**PIC16C63A/65B/73B/74B**

## **PIC16C63A/65B/73B/74B Data Sheet Errata**

The PIC16C63A/65B/73B/74B parts you have received conform functionally to the Device Data Sheet (DS30605C), except for the anomalies described below.

**FIGURE 10-1: SSP BLOCK DIAGRAM (SPI MODE)**

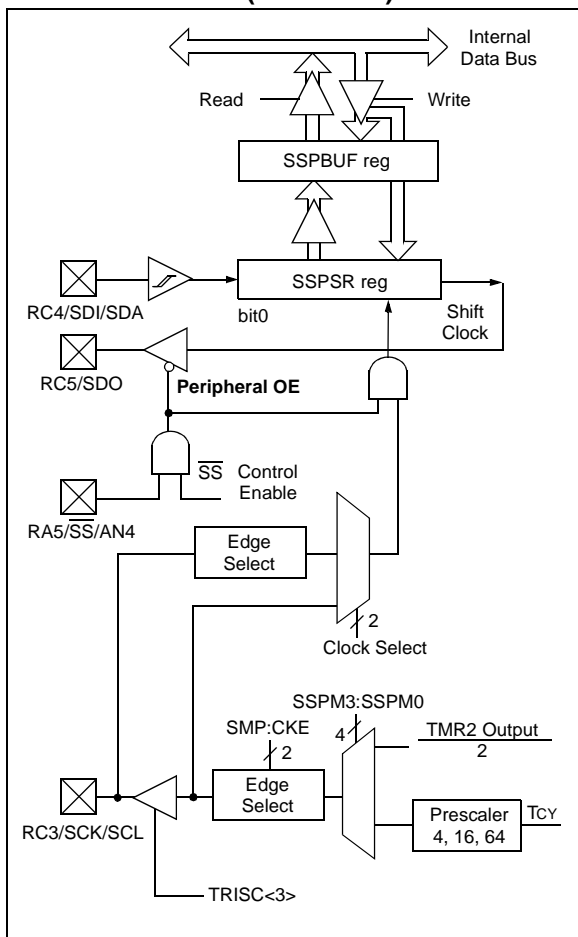
In Section 10.2 (“SPI Mode”), Figure 10-1 and the note box immediately beneath it have been amended to better demonstrate the Peripheral OE line of the SSP module and describe its relationship to the TRISC<5> bit of PORTC.

Changes are indicated in **bold**.

**Note 1:** When the SPI module is in Slave mode with  $\overline{SS}$  pin control enabled (SSPCON<3:0> = 0100), the SPI module will reset if the  $\overline{SS}$  pin is set to VDD.

**2:** If the SPI is used in Slave mode with CKE = '1', then  $\overline{\text{SS}}$  pin control must be enabled.

3: When the SPI is in Slave mode with `SS` pin control enabled (`SSPCON<3:0> = 0100`), the state of the `SS` pin can affect the state read back from the `TRISC<5>` bit. The Peripheral OE signal from the `SSP` module into `PORTC`, controls the state that is read back from the `TRISC<5>` bit (see Section 5.3 for information on `PORTC`). If Read-Modify-Write instructions, such as `BSF`, are performed on the `TRISC` register while the `SS` pin is high, this will cause the `TRISC<5>` bit to be set, thus disabling the `SDO` output.

**FIGURE 3: 28-PIN QFN PACKAGE (DRAWING 1, PACKAGING)**

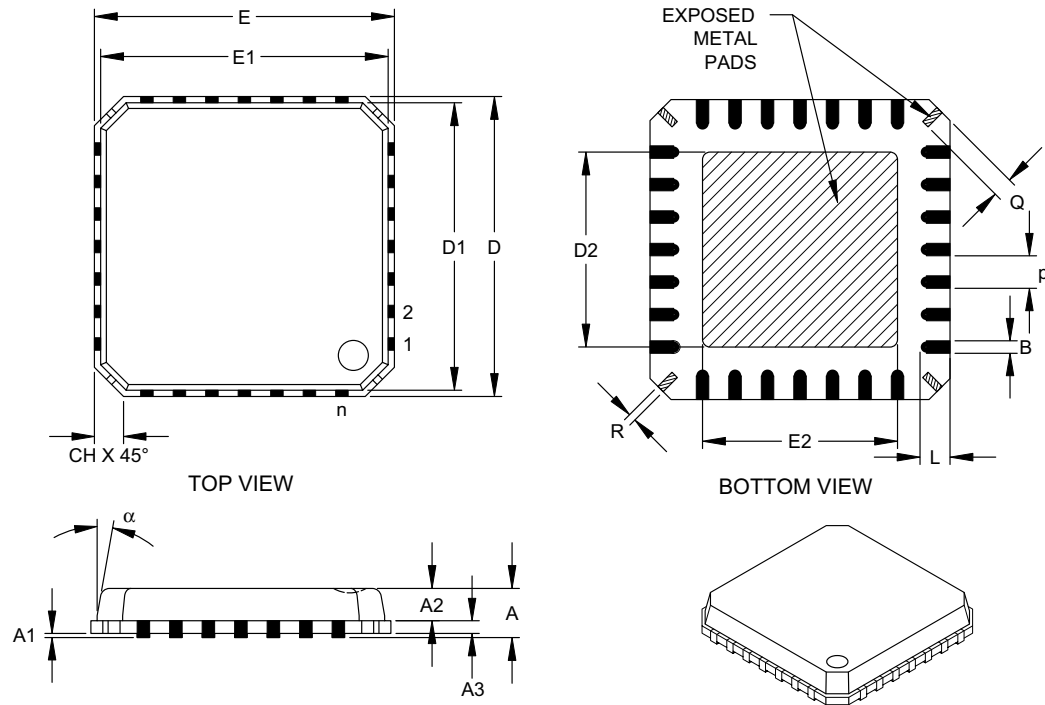
PIC16C63A and PIC16C73B devices are now offered in 28-pin near chip-scale micro lead frame packages (commonly known as “QFN”). This packaging type has been added to the product line since the latest revision of the Device Data Sheet.

The addition of this option requires the following additions to the Device Data Sheet. The referenced figures and tables follow this text.

**28-Lead Plastic Quad Flat No Lead Package (ML) 6x6 mm Body, Punch Singulated (QFN)**
